# Service Bulletin

NO.1284

Revised July, 1992

**Subject: Cover sub-assembly and Charge Pump (Pump Plate)  
Model 11 Transmissions, Model 11 Pumps, 1150 Transaxles, with  
external charge pump inlet.**

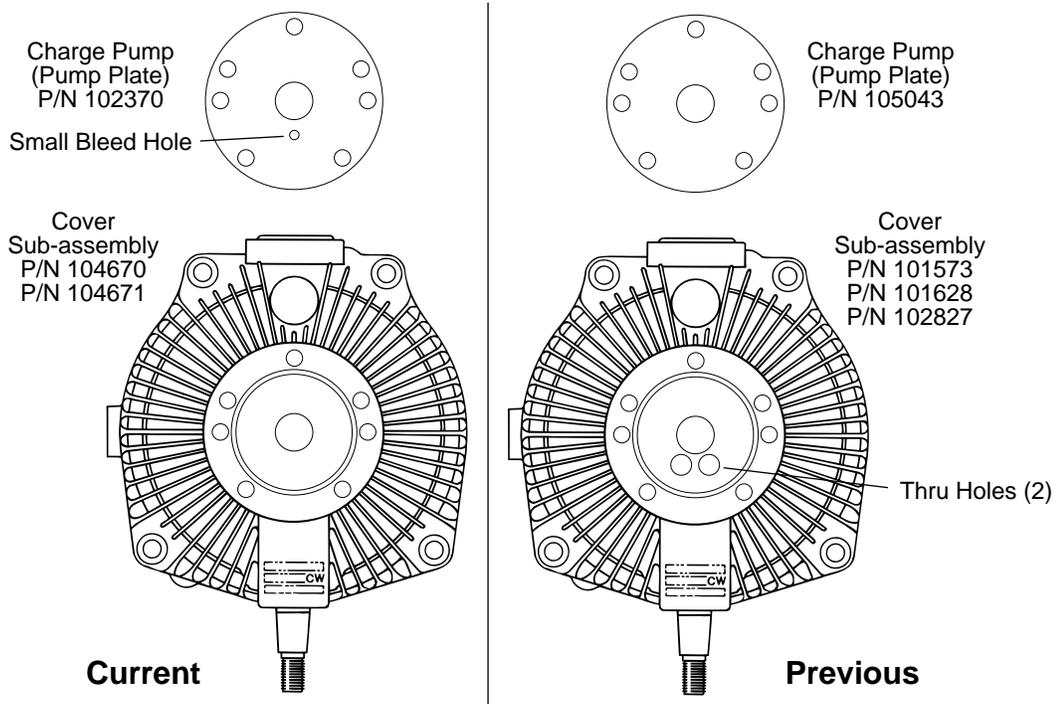
Current cover sub-assemblies are manufactured *without* thru holes between the charge pump *pump plate* and internal case, a bleed hole was added to the pump plate.

**Note:** Current Cover sub-assembly *without* thru holes, requires Pump Plate *with* bleed hole.

Cover sub-assembly *with* thru holes will require the Pump Plate *without* bleed hole.
